ADDENDUM NO. 1 - OUTLINE AND SUMMARY INFORMATION

Project Name: Plant Bio-Science Chiller Replacement PPA No.: 20-0109
Location: Montana State University - Bozeman Date: 12-10-20
Owner: State of Montana, MSU - Bozeman
Plew Building 6th and Grant, PO Box 172760
Bozeman, Montana 59717-2760

N 1 FIRST FLOOR POWER PLAN
SCALE: NOT TO SCALE

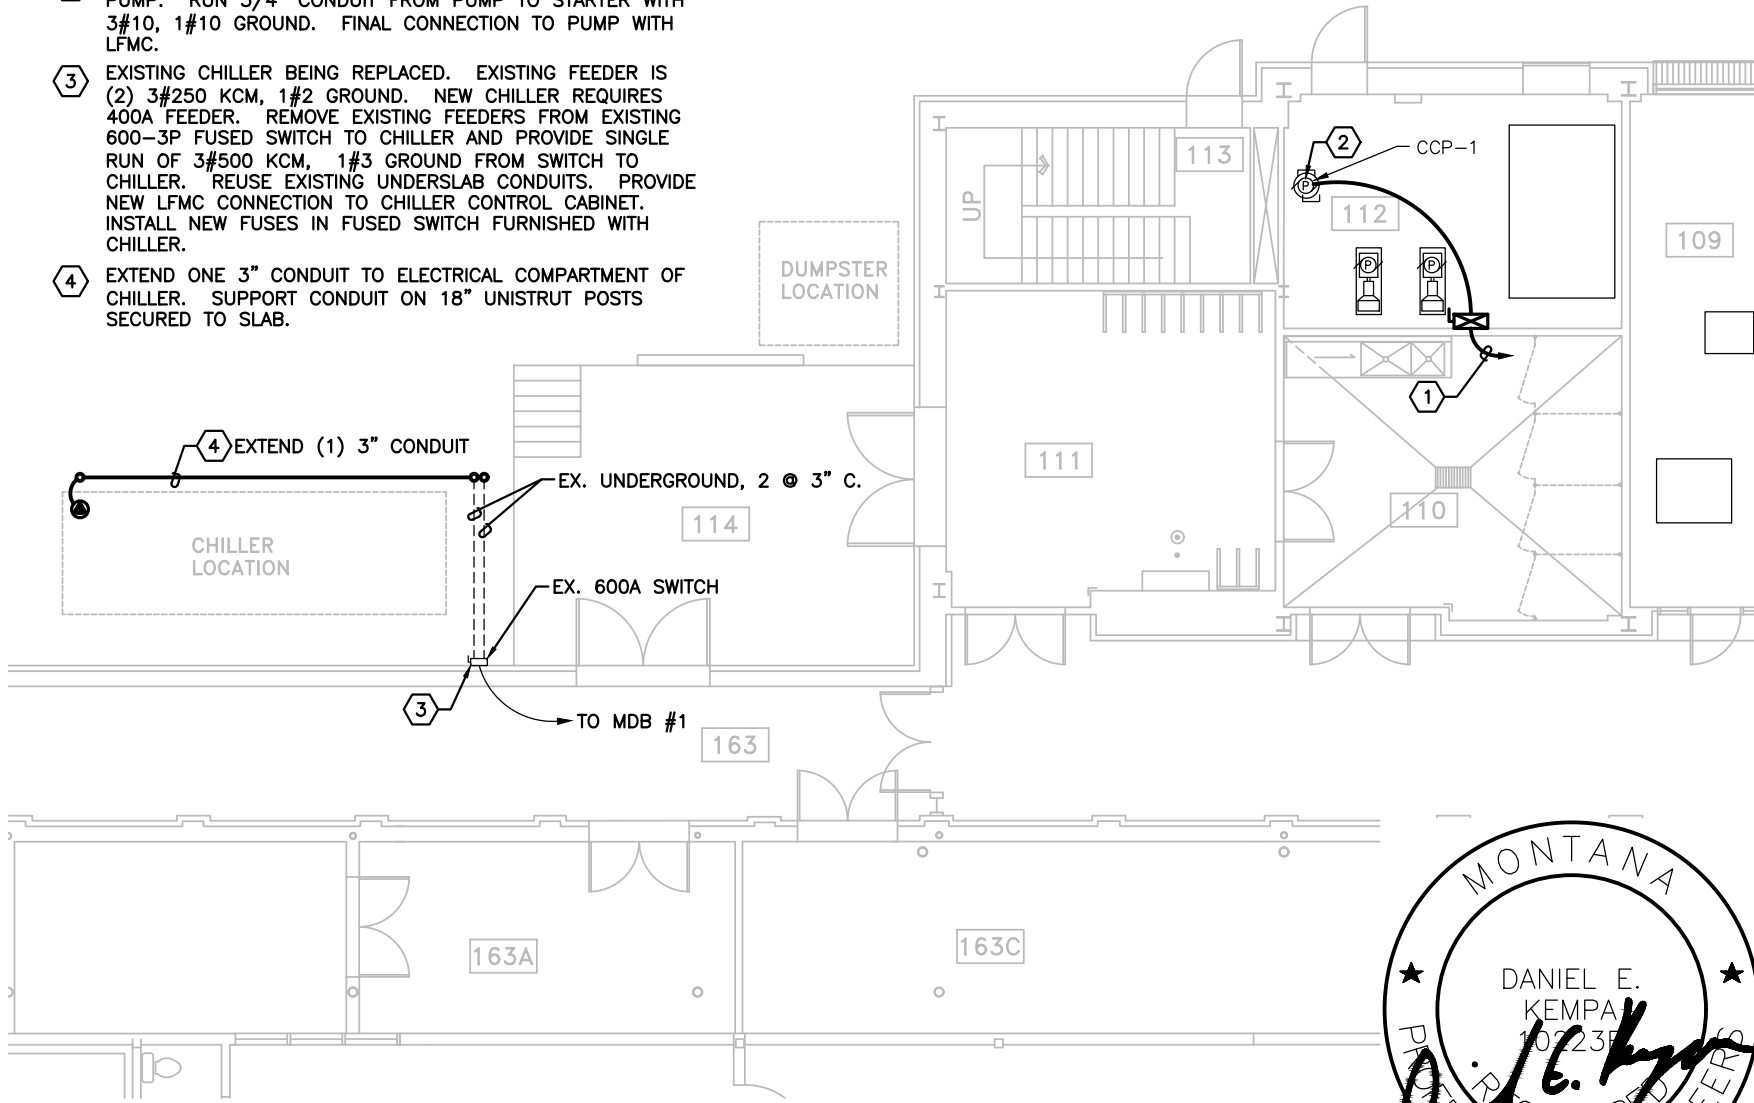
- a. Electrical Sheet E1.0 - First Floor Power Plan:
 - i. Add attached Sheet E1.0 to construction documents.
 - ii. Add sentences to note 2 to read “Disconnect existing pump and remove wiring and conduit back to starter. Leave starter and upstream electrical service in place.”

- iii. Modify second sentence of note 4 to read “Support conduit on Uni-Strut posts secured to slab. Coordinate location and height with Owner to ensure proper access to chiller equipment”.

KV Series Pump | Submittal Data

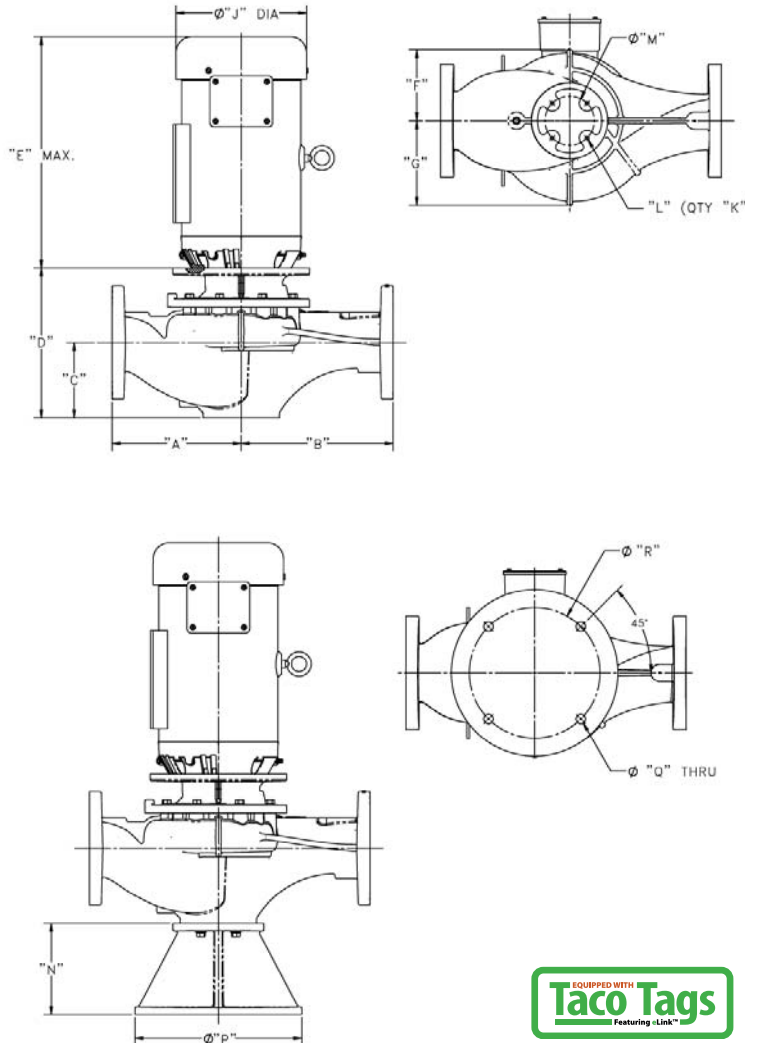
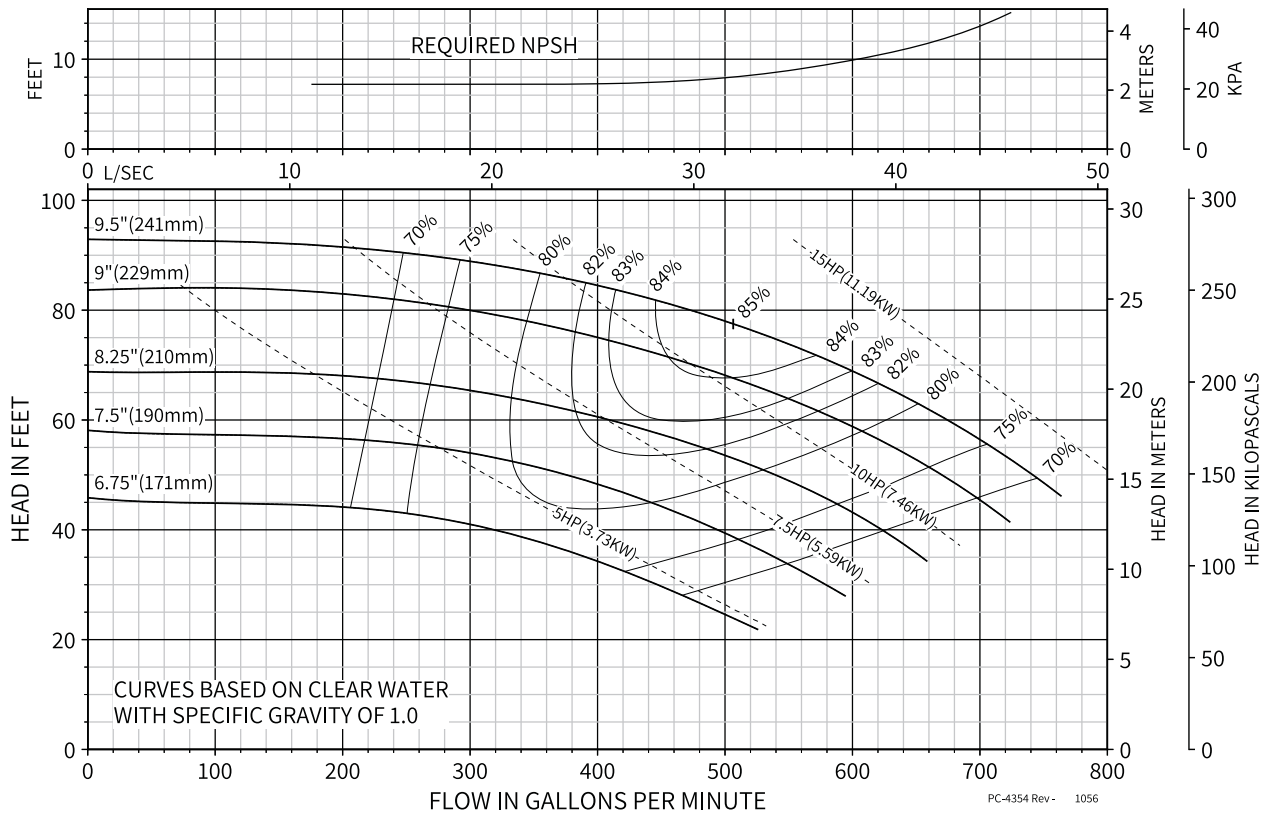
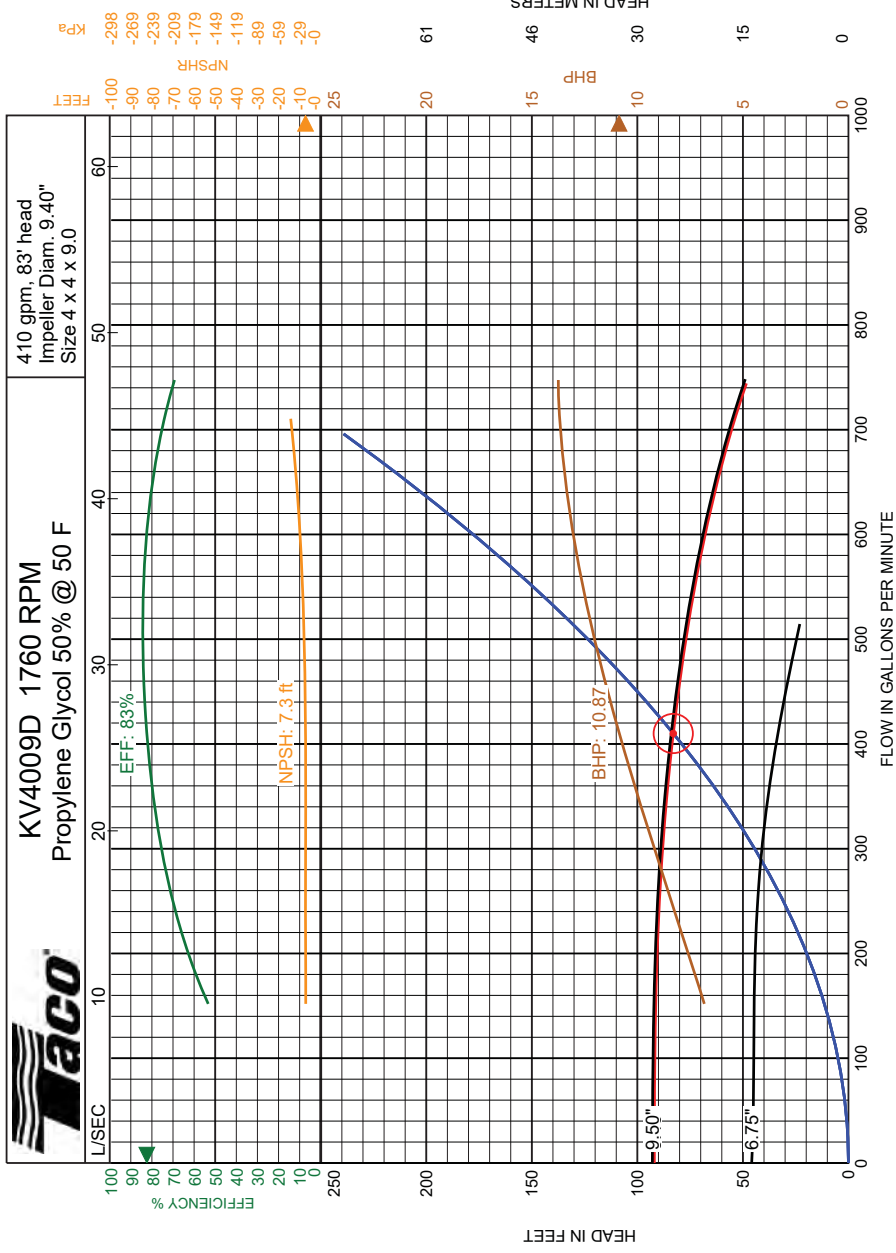
a. New Chiller Pump Data Sheets: Replace data sheets for new chiller pump with attached. Pump is same model but new data sheets include motor, flow, and pressure information.
